HPC EXECUTIVE SECRETARY
 EXEMPTION DETERMINATION FOR MINOR ALTERATIONS
 AND TAX CREDIT PRE-APPROVAL

**3801 Old Columbia Pike, Ellicott City
Minor Alteration Determination**

~~AMENDMENT~~
~~GENERAL APPLICATION FOR CERTIFICATE OF APPROVAL AND~~
~~TAX CREDIT PRE-APPROVAL~~

This document amends original approved HPC-20-54 dated August 6, 2020 application AND conforms to the approved MHT 2020 - 161 dated December 10, 2020 application.
SUBMIT 10 COPIES of this application package, including all supporting materials required on pages 2-5 of this application to Howard County Department of Planning and Zoning. Applications must be received no later than 5:00 pm 22 days prior to the meeting. Applications can be submitted via mail, but may result in missing the deadline. Applications are not accepted via email or fax.

1 new rear (south) elevation
 scale: 1/4" = 1'-0"

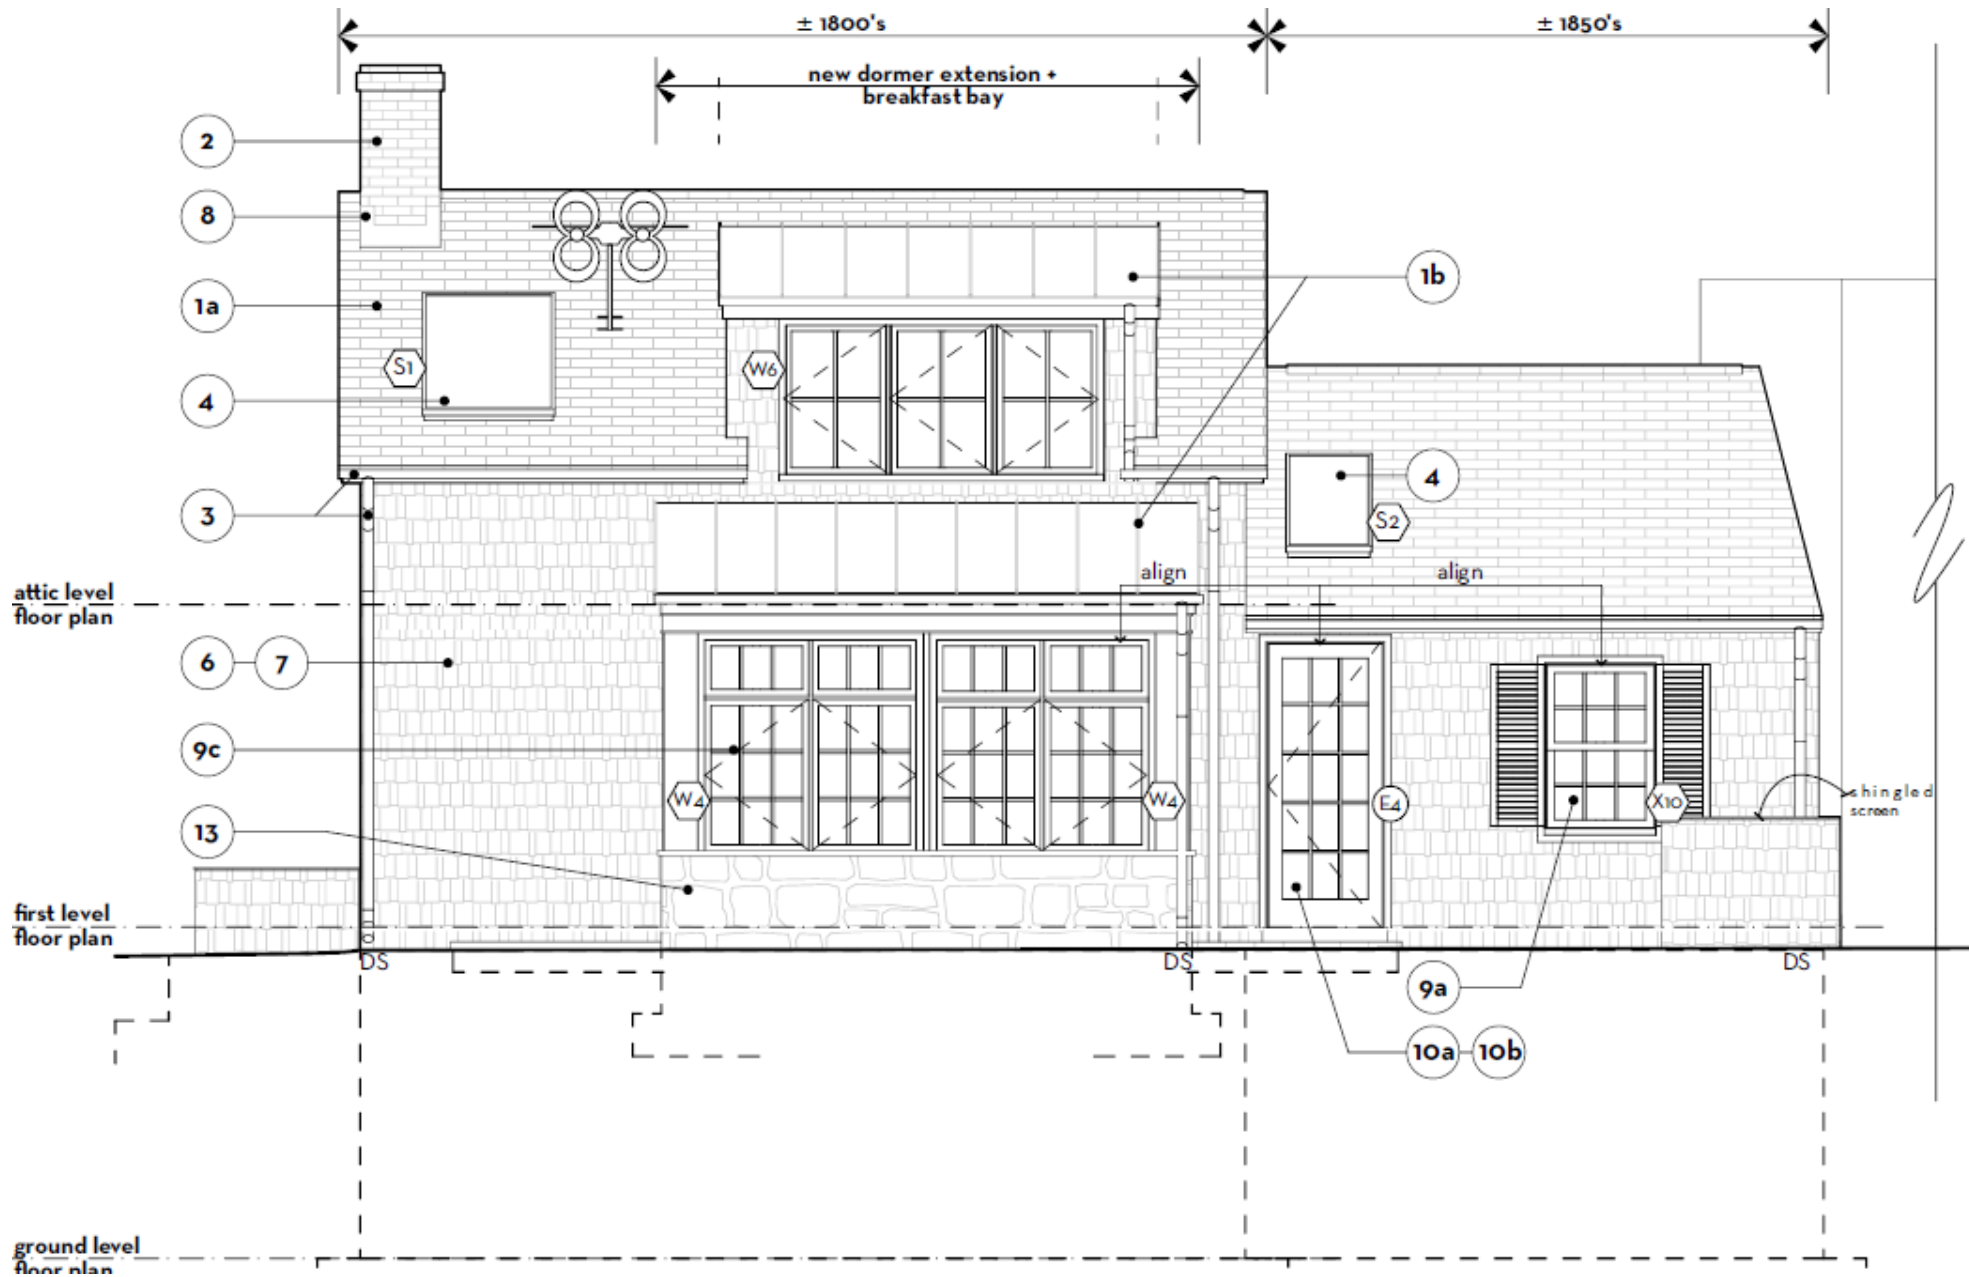
Dormer: The rear dormer size and associated windows have been reduced in size to address MHT comments to keep with the historic character of the house and have been reduced from 3 proposed windows in the dormer, to two.

Current proposal/alteration to adhere to MHT approval

Previously approved

- Work Item #7: We have revised the design of the rear, attic dormer to reflect MHT comments. It is now 1'-6" less in width with the window configuration reduced from 3 to 2. This is the minimum width allowing for an egress casement. The new dormer continues to align with the first floor wall as the current dormer does. Its structure rests on the outside wall, and any alteration to face of dormer moving inward toward the roof would require modification to existing wall and roof structure.
(Summarized Item Response continues on next sheet)

Existing front door

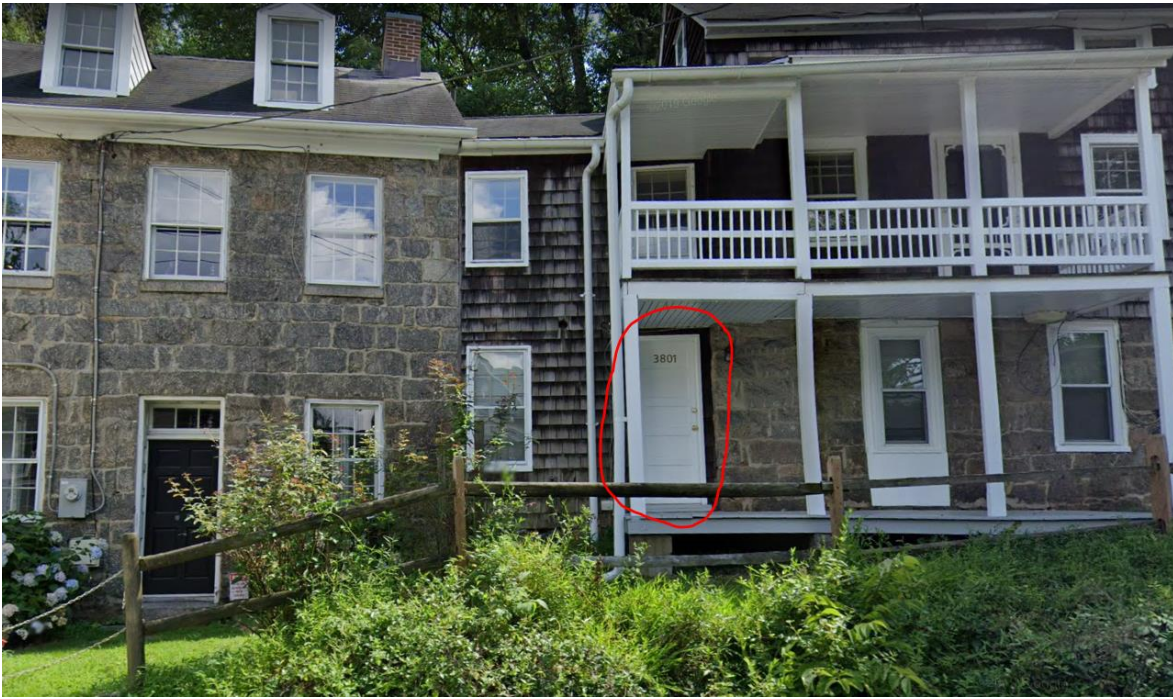
Front door: The property owner is considering changing the front door from the previously approved 9 light over 2 panel, to a solid 6 panel wood Simpson door, in the style Nantucket. The existing door is a modern replacement door and is not historic. The 6 panel Nantucket door would match the front door on the adjoining neighboring building. They are waiting to hear if MHT will approve the door.

Applicant proposes to change to this style of door, if MHT approves the change.

SPECS

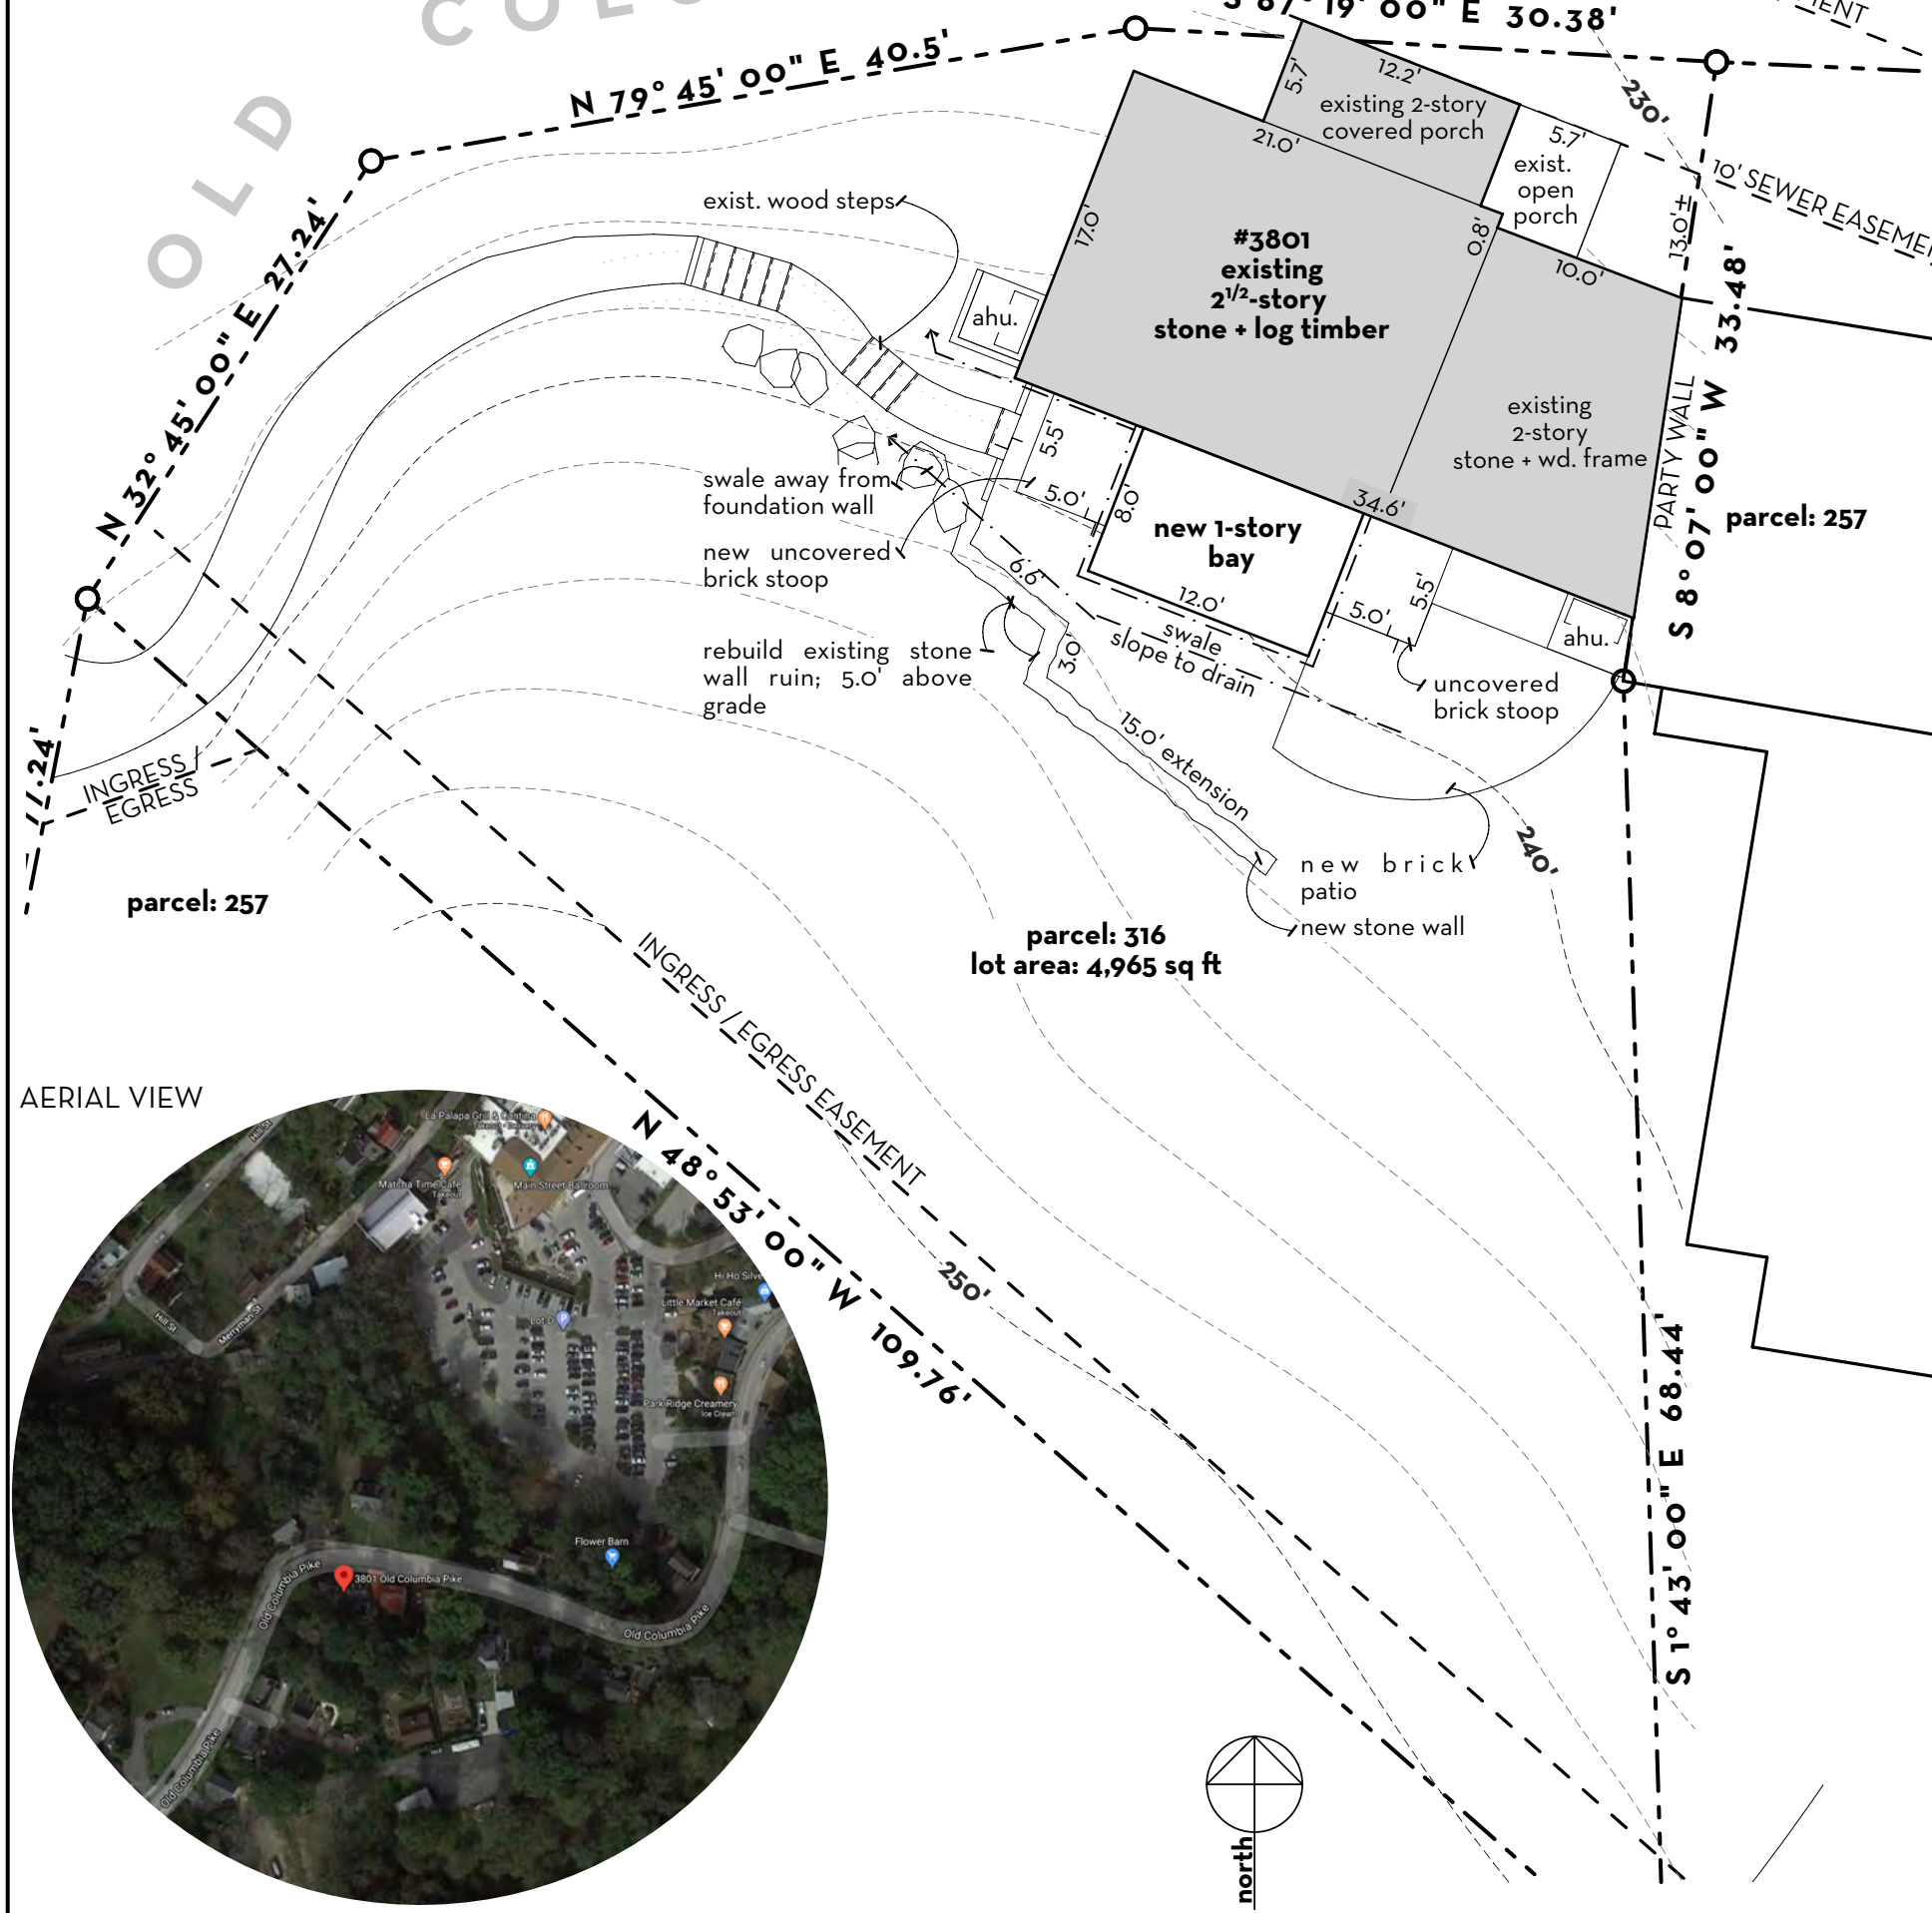
Roof: The asphalt shingle roof was originally approved to be Certainteed Landmark Series charcoal black. The Applicant now seeks approval for Certainteed XT30-IR Colonial Gray, flat 3-tab style shingle as an in-kind replacement to match the existing roof shingle.

- Work Item #3: We will substitute a Certaineed XT 30-IR Colonial Gray, flat 3-lab style shingle as an in-kind replacement. See attached spec sheet.
